NVM Express® Technical Errata

Errata ID	105
Revision Date	10/03/2022
Affected Spec Ver.	NVM Express® Base Specification Revision 2.0b NVM Express® NVM Command Set Specification Revision 1.0b NVM Express® Zoned Namespace Command Set Specification Revision 1.1b NVM Express® RDMA Transport Specification Revision 1.0a NVM Express® TCP Transport Specification Revision 1.0b NVM Express® Management Interface Revision 1.2b
Corrected Spec Ver.

Errata Overview

Figure 122: SGL Read Example

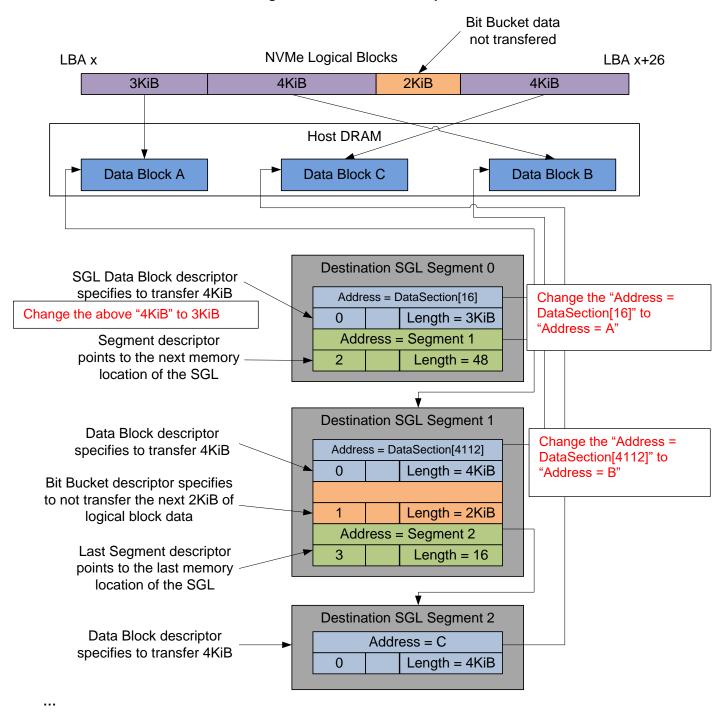
Correct errors in Figure 122 (section 4.1.2.1) that were introduced by the "KB" to "KiB" changes in revision 1.4 (correct size of the "A" descriptor; correct the address pointer for segment "A" and "B").
